Subject: Oyster Creek Generating Station
Facility Operating License No. DPR-16
NRC Docket No. 50-219

Technical Specification Change Request No. 328 – Modify Surveillance
Requirements for Testing of Main Steam Line Electromatic Relief Valves

Oyster Creek Technical Specification Change Request No. 328

Inservice Testing Program Code Relief Request No. RV-53

Figure 1

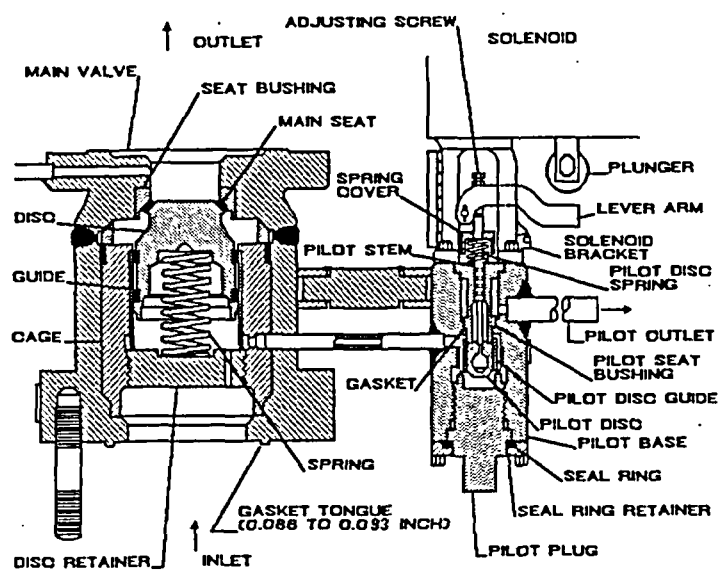
There are five Dresser EMRVs, model 1525VX, on the main steam lines between the reactor vessel and the main steam line isolation valve within the drywell. The EMRVs consist of a main valve assembly, pilot valve assembly, and a solenoid actuator (see Figure 1). The EMRVs are opened by automatic or manual switch actuation of a solenoid. When energized the solenoid actuates the plunger, which pushes down the pilot valve operating lever, thereby opening the pilot valve. When the pilot valve opens, pressure under the main valve disc is vented. This results in an unbalanced steam pressure across the main disc, which moves the main disc downward from its seat thereby opening the main valve.

The proposed revision to the surveillance requirement (SR) provides an alternative method of verifying EMRVs operability. Current TS 4.4.B.1 requires an operability test utilizing the main steam pressure to stroke the EMRV. The proposed alternative test would verify EMRV operability by stroking the EMRV actuator using the manual switch every 24 months. The alternative test would be performed with little or no reactor pressure on a 24 month frequency. Stroke testing of the EMRV main valve will continue to be performed in accordance with the Inservice Testing (IST) program as modified by the attached relief request. Additionally, each valve is removed, refurbished, and stroke tested every two (2) refueling outages. The stroking of the EMRV actuator every 24 months, in combination with the removal, refurbishment, and stroke testing of the valve every two (2) refueling outages will provide a complete verification of the EMRV functional capability.

The alternative test will be performed with the solenoid actuator mounted in its normal position. This will allow testing of the manual actuation electrical circuitry, solenoid actuator, pilot operating lever, and pilot valve assembly. This test will verify pilot valve movement. However, since this test will be performed in the absence of the reactor pressure needed to overcome main valve closure spring force, the main valve will not stroke during the test. Stroking the pilot valve in the absence of steam pressure is referred to as "dry cycling."

“Verify each relief valve actuator strokes when manually actuated.”
